**NEXTERA ENERGY POINT BEACH, LLC
POINT BEACH NUCLEAR PLANT, UNITS 1 AND 2**

**LICENSE AMENDMENT REQUEST 261
EXTENDED POWER UPRATE**

NON-PROPRIETARY RESPONSE TO REQUEST FOR ADDITIONAL INFORMATION

December, 2009

Figure 21a: Pressurizer Pressure

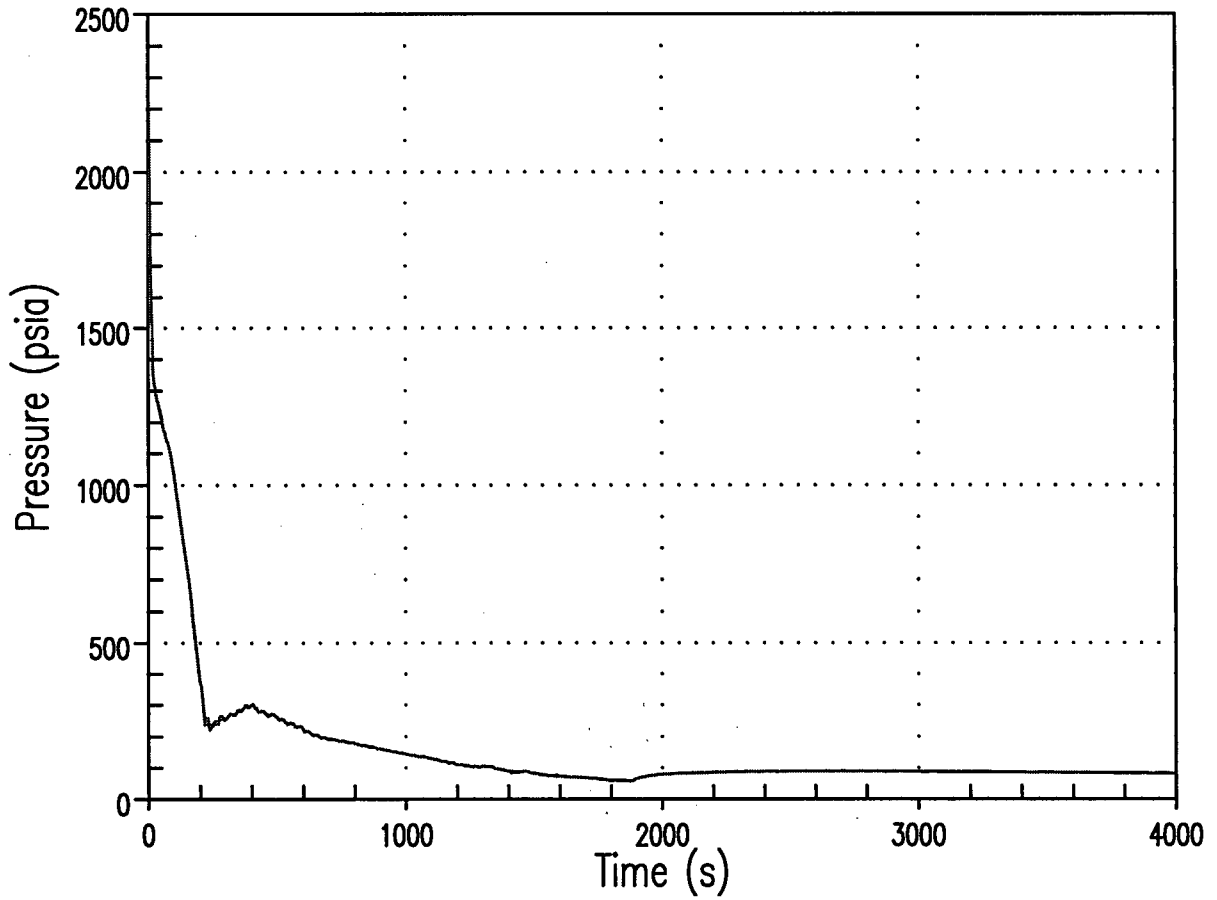
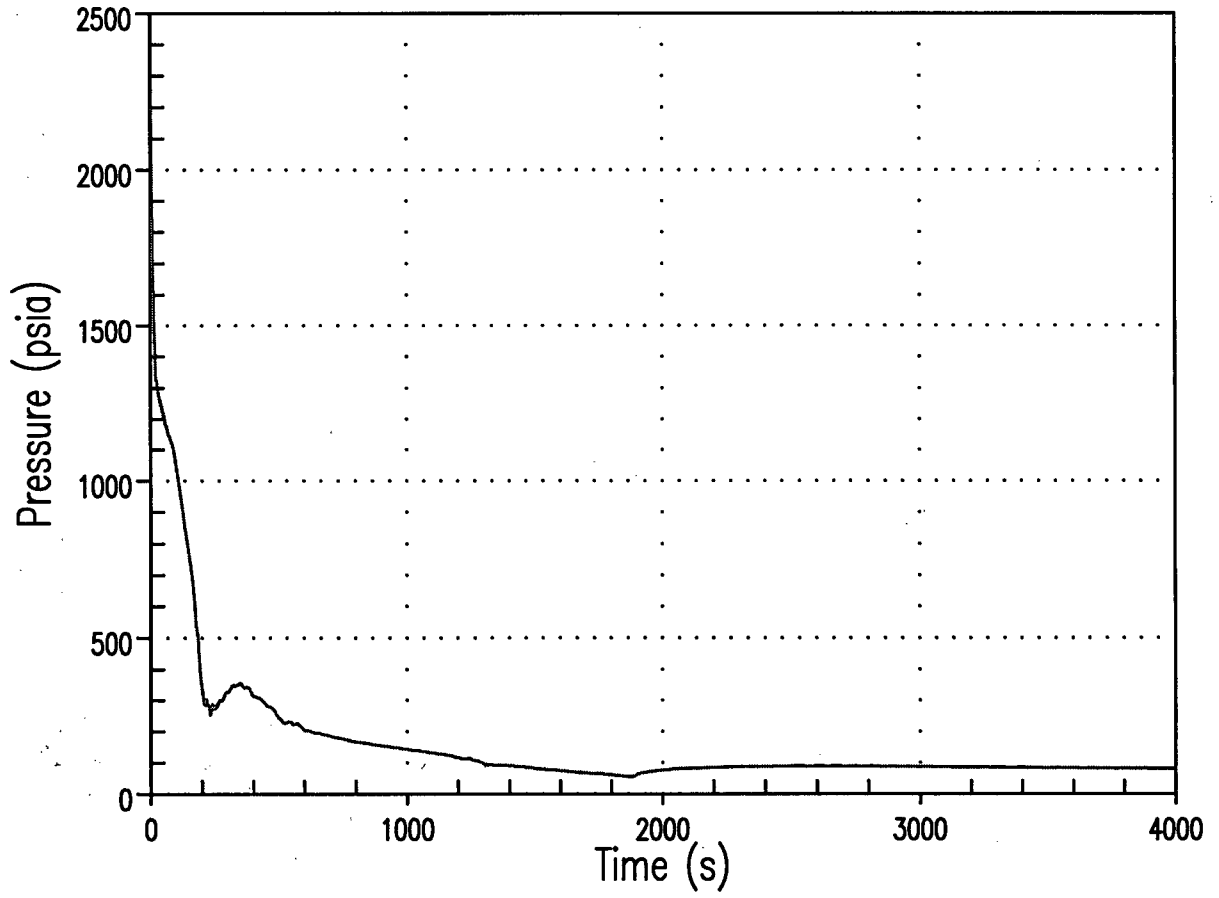
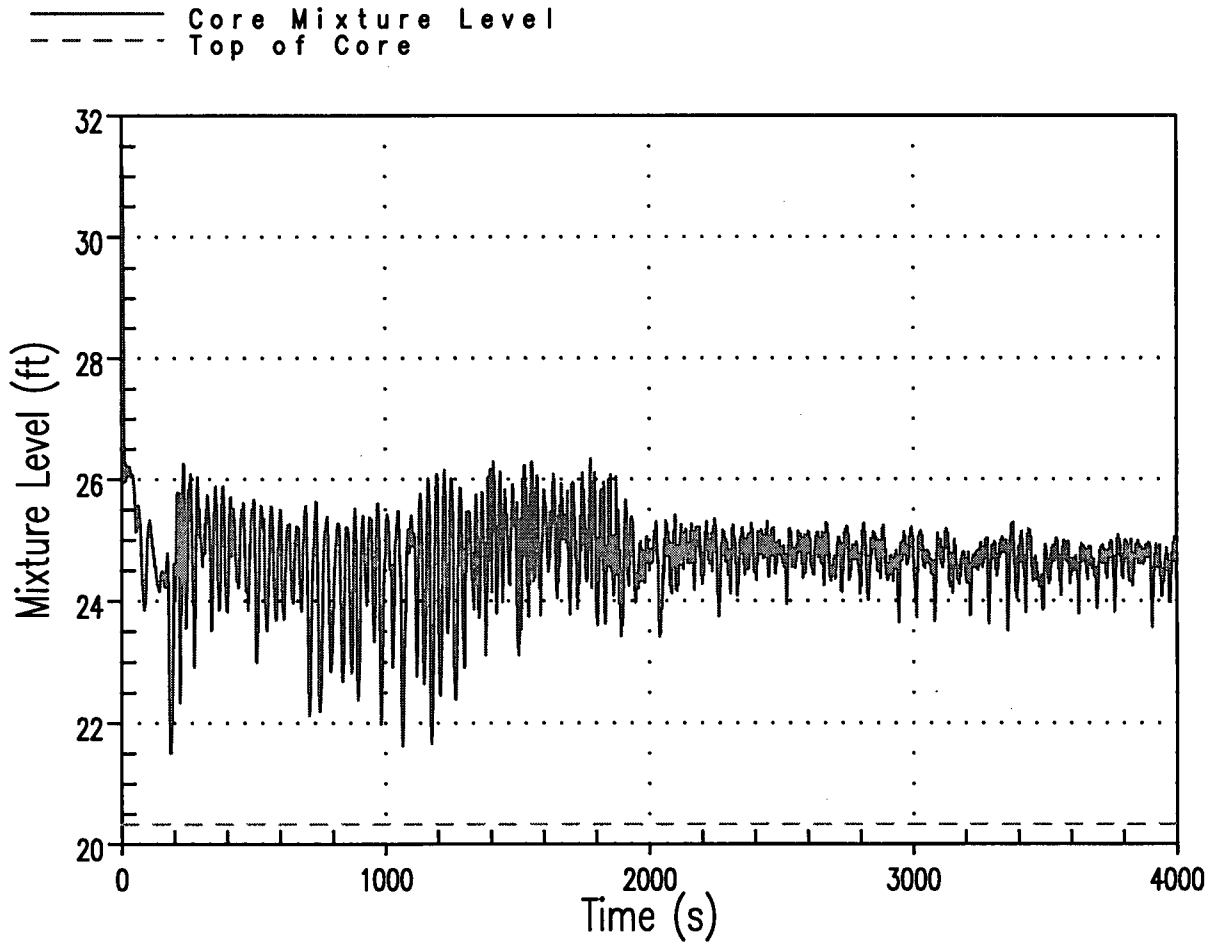
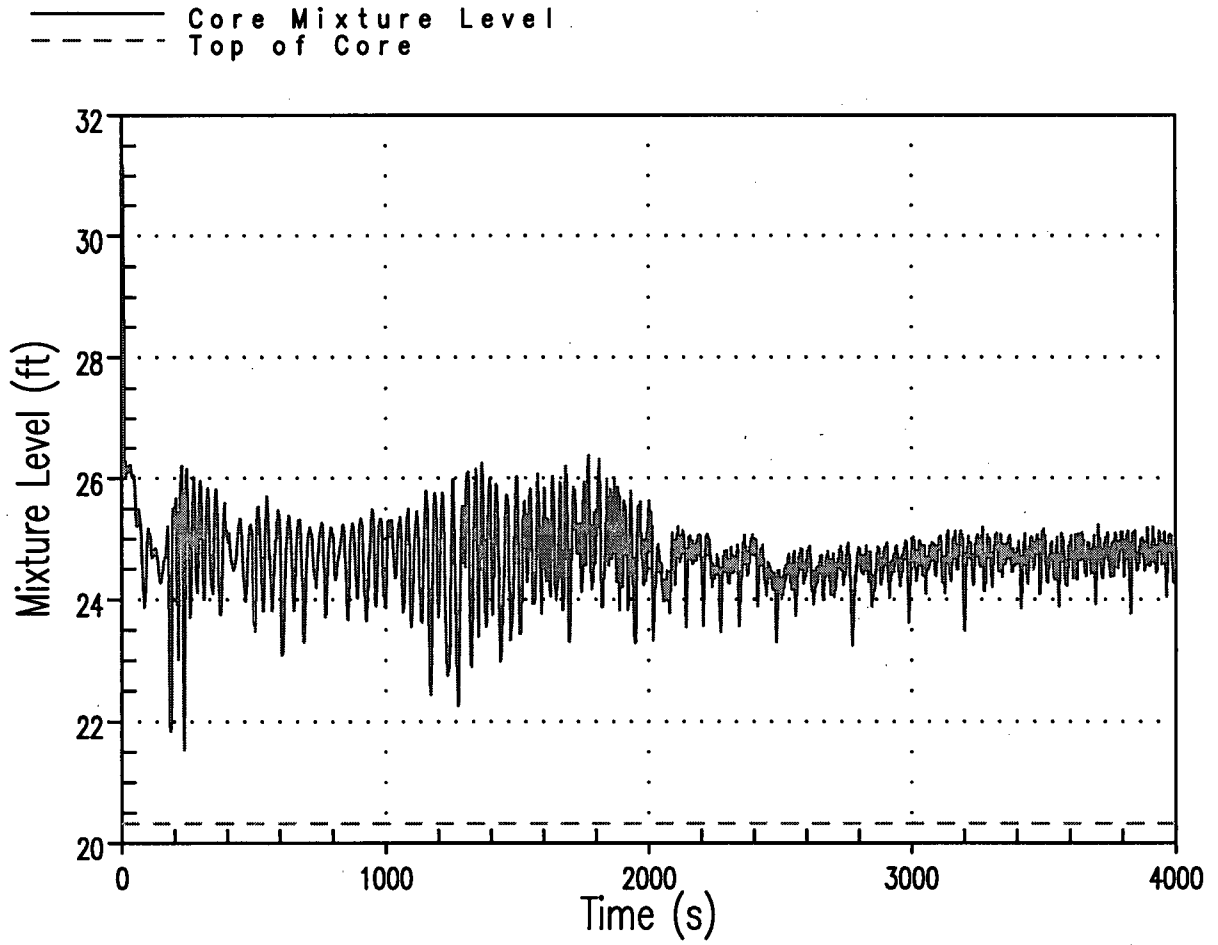
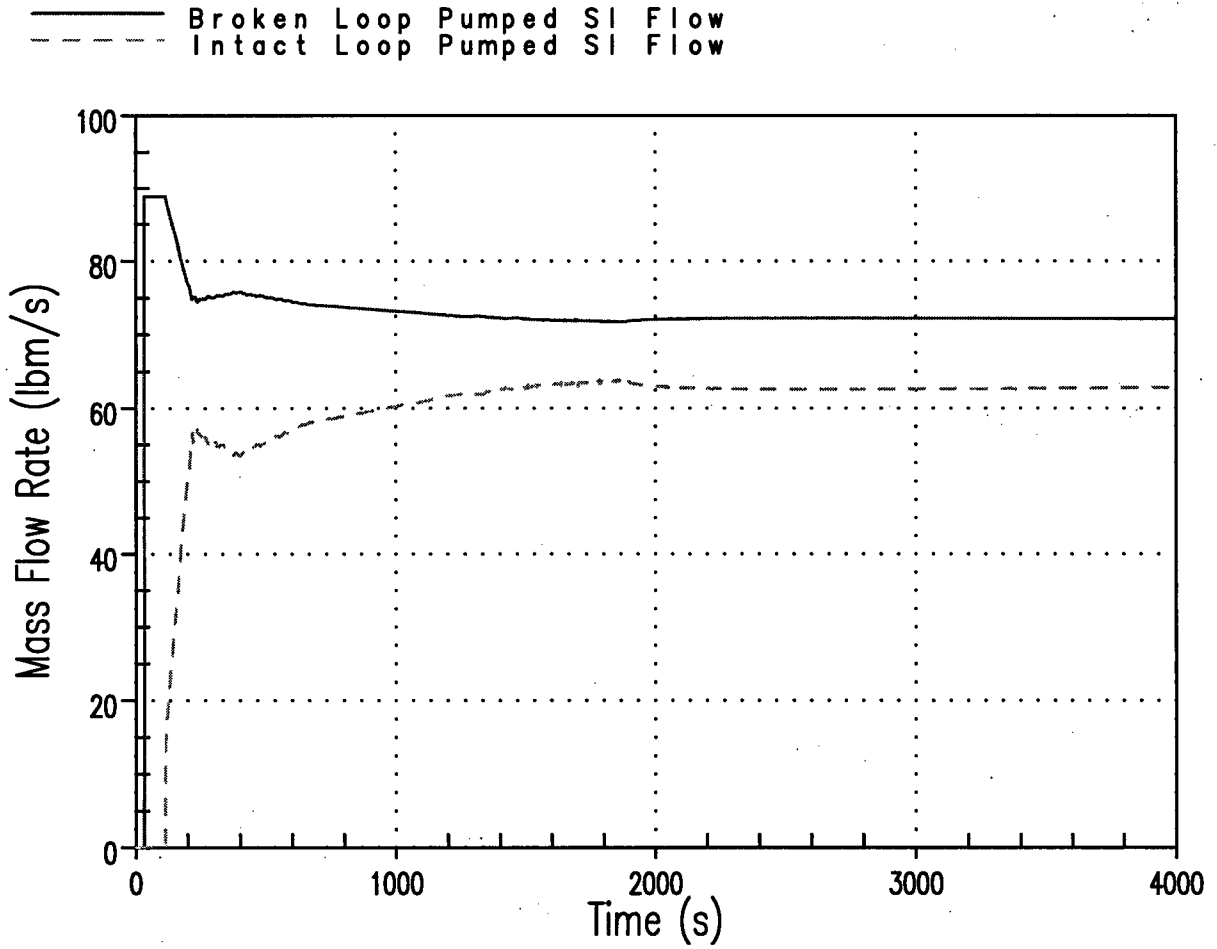
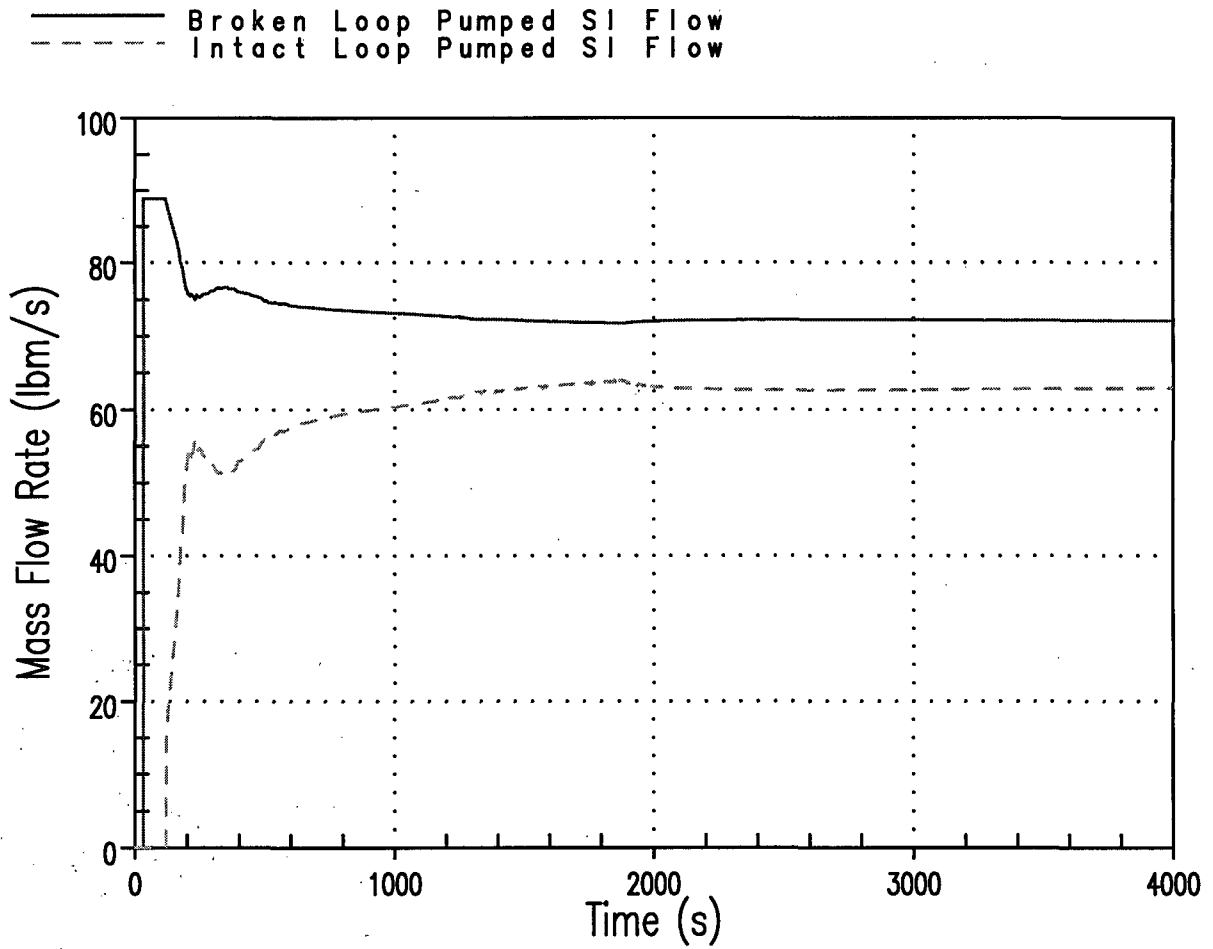
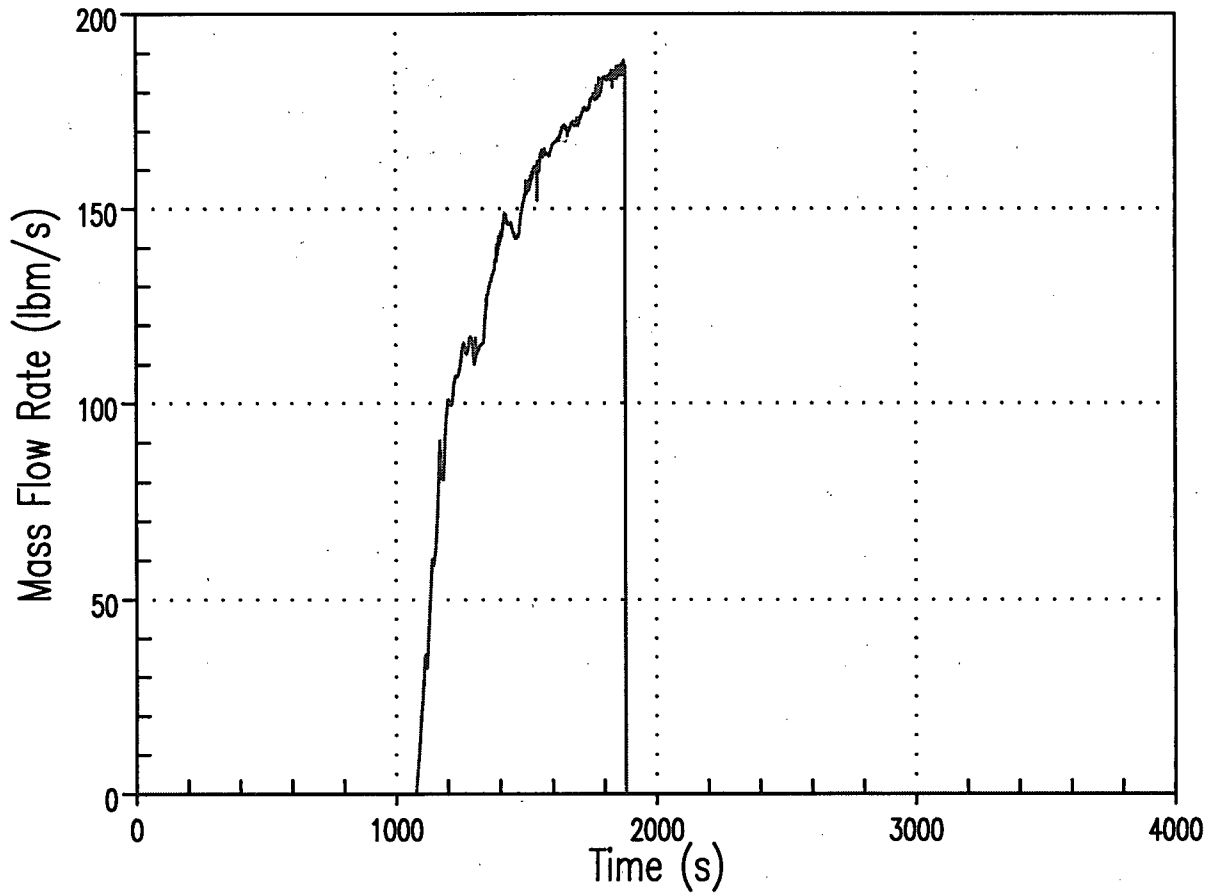
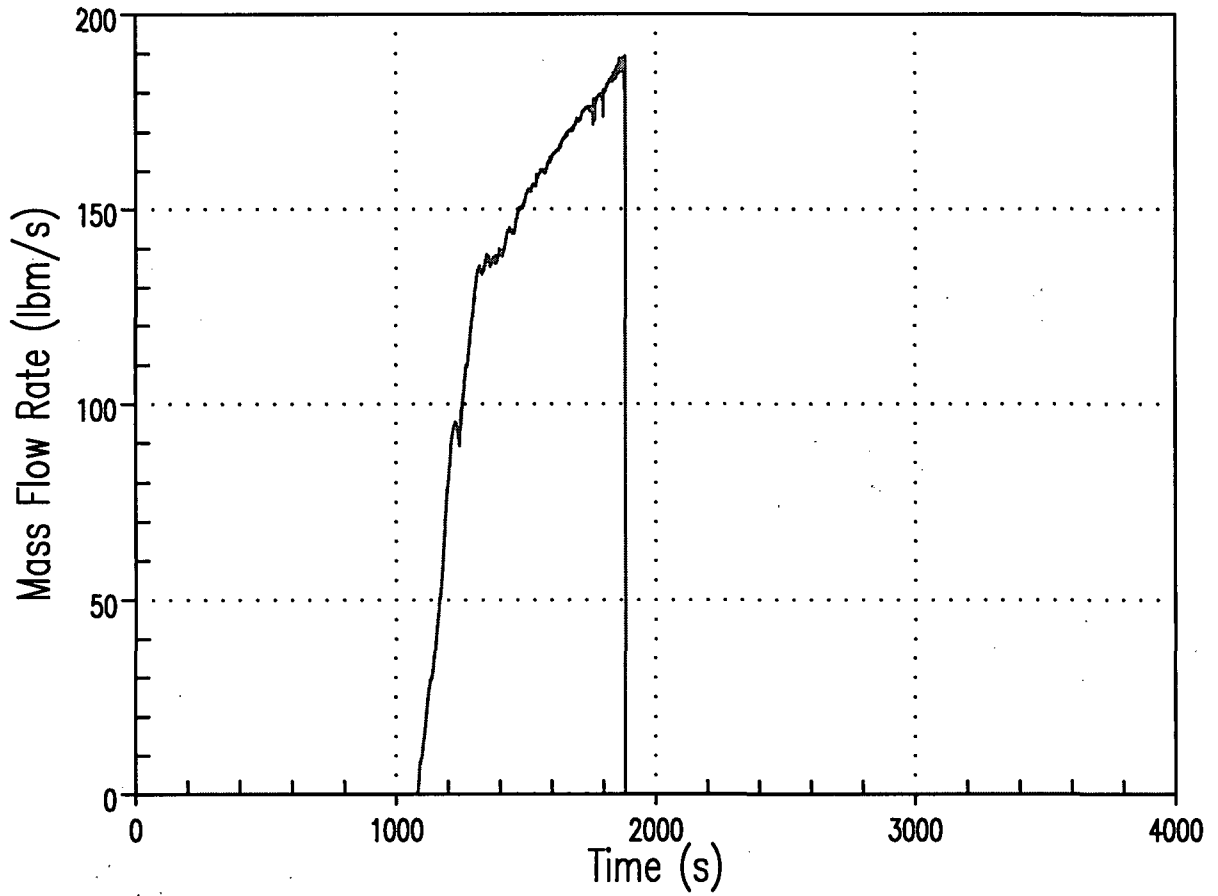
- 1) Page 2.8.5.6.3-6 of the Point Beach Extended Power Uprate (EPU) Licensing Report (Enclosure 5 to Reference 1) indicates that the small-break loss-of-coolant accident analysis was performed using the NOTRUMP evaluation model. Please provide a copy of the NOTRUMP analysis report that supports the EPU application.**

The NRC reviewer provided clarification of this RAI during a teleconference held between Westinghouse, FP&L, and the NRC. It was concluded that the transient response results of the non-limiting breaks, which are not provided in the LAR, will be provided. Transient response results for the limiting 3-inch break for both Point Beach Units 1 and 2 are provided in the small break LOCA LAR Section 2.8.5.6.3. The same response results for the non-limiting breaks are provided below. The following comments apply:

- Peak cladding temperature transients are not provided for the 6- and 8.75-inch breaks as these breaks experienced little to no core uncover.
- Low head safety injection flow figures are provided only for the 6- and 8.75-inch breaks. LHSI was only modeled for the 6- and 8.75-inch breaks (during RWST injection phase only). Breaks less than 6-inches in equivalent diameter did not reach the LHSI cut-in pressure.
